CONTRACT ADDENDUM NO. 1

**CITY OF MOUNT VERNON PROJECT#
TS-2019-001: 2018 STREET AND CURB RAMP IMPROVEMENTS**

DATE OF ISSUE: AUGUST 23, 2019

Item No. 1: UPDATED PLAN SHEET MSA

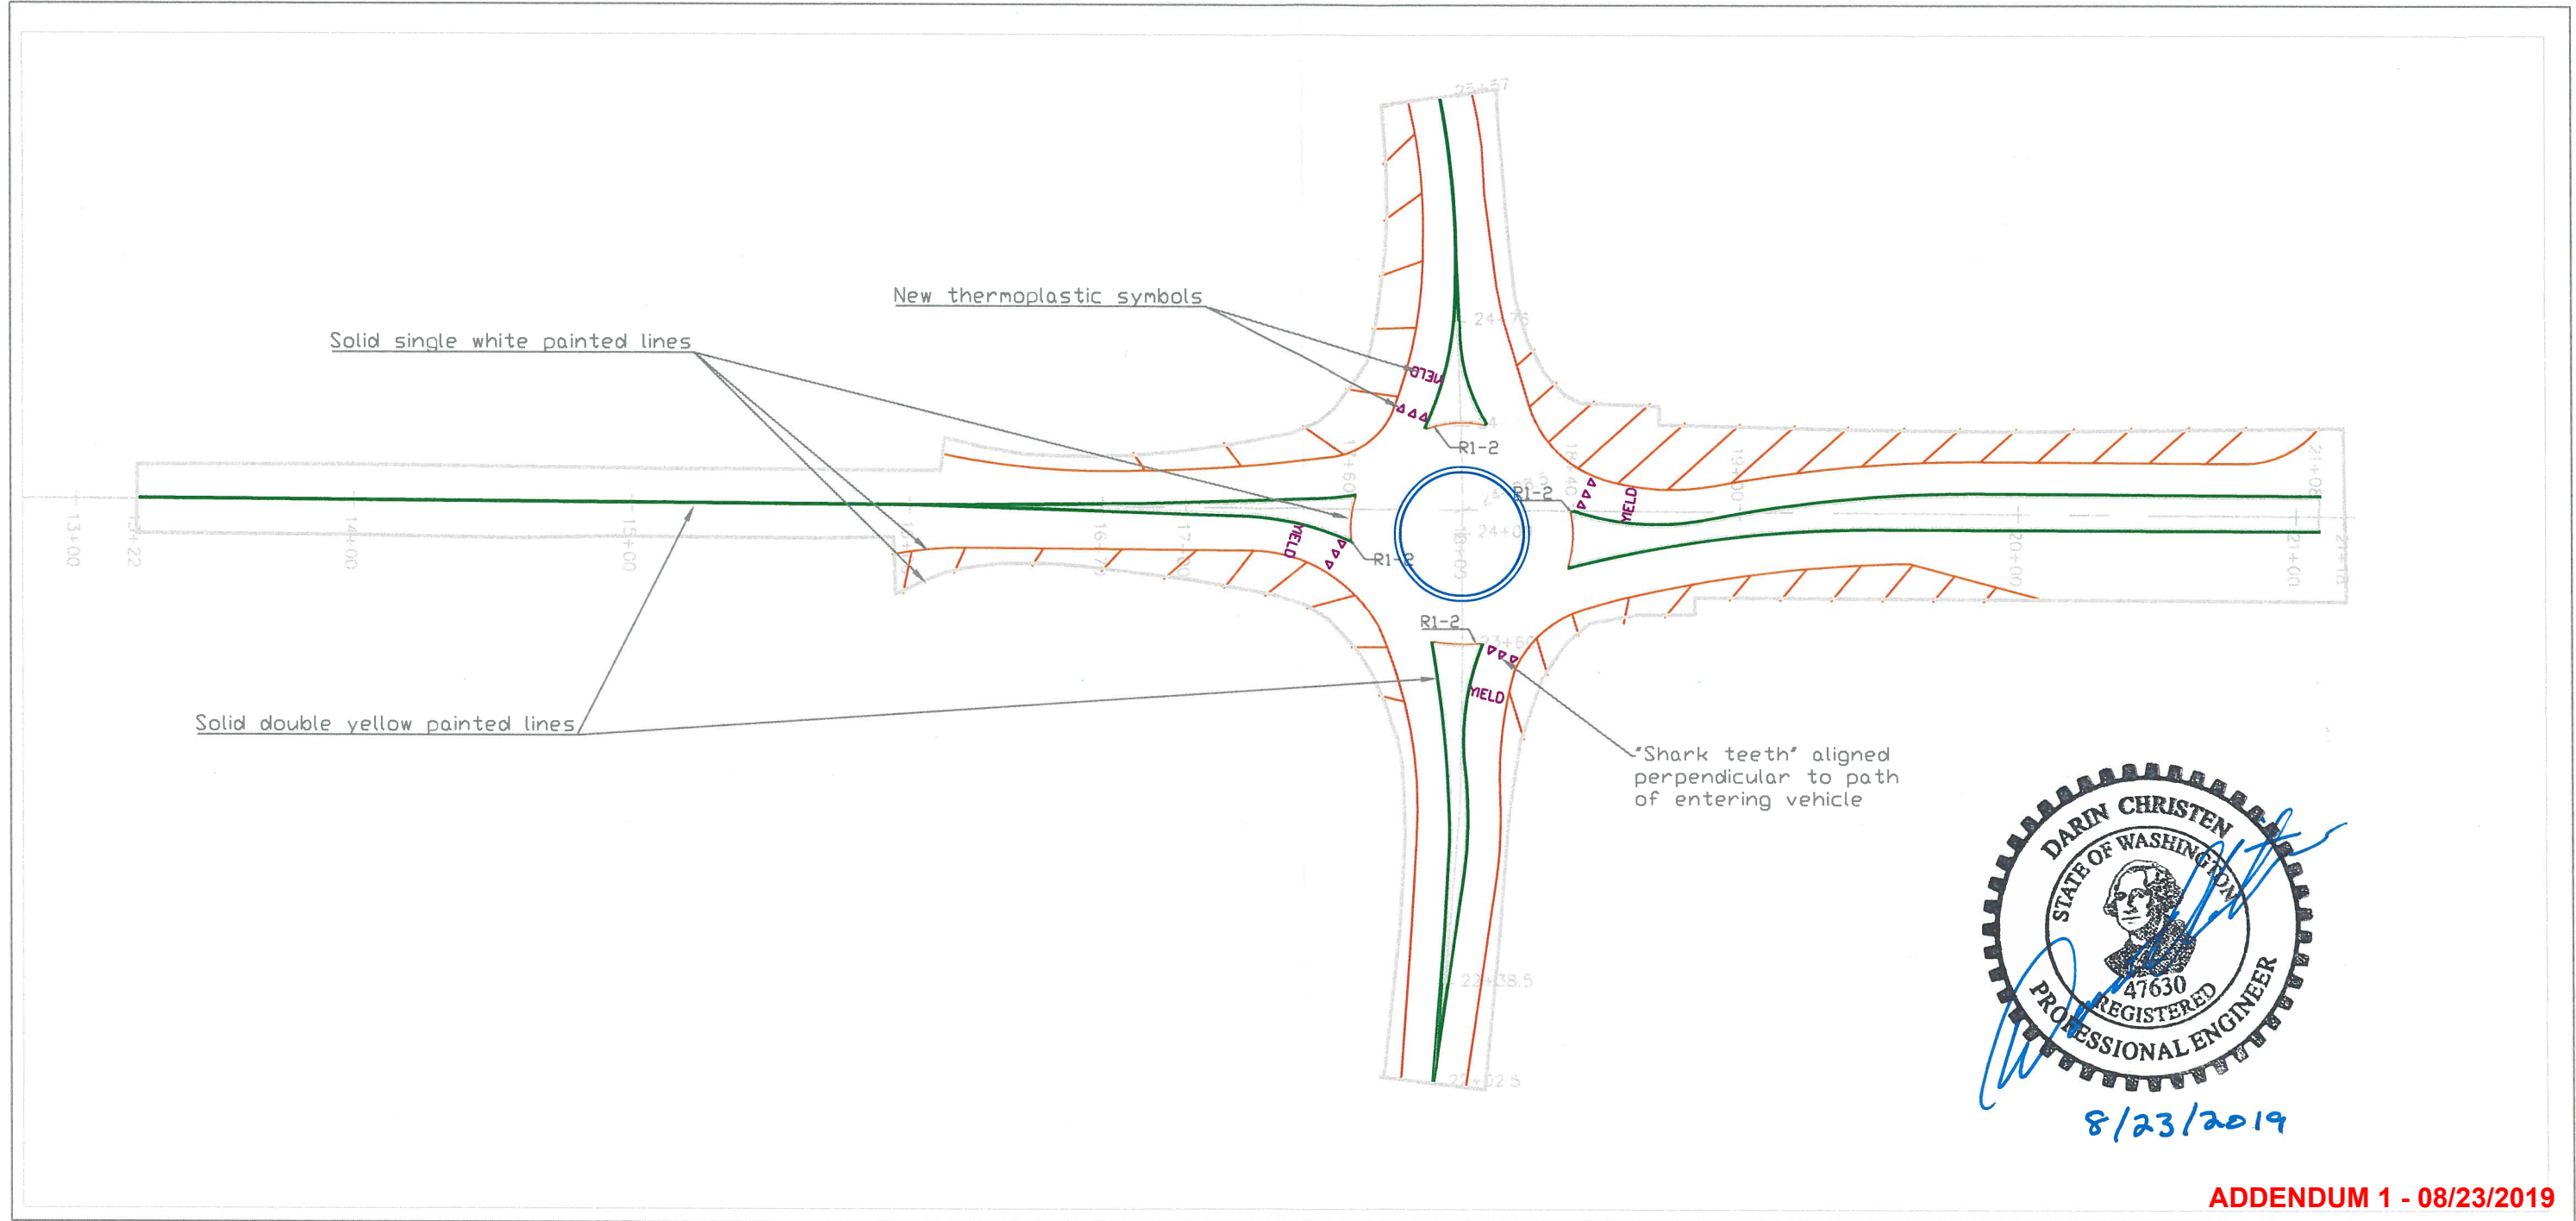
Plan sheet MSA is replaced with the attached sheet MSA including but not limited to the following changes:

1. Deleted redundant callout for yield signs.
2. Deleted callout to paint splitter islands and central islands.
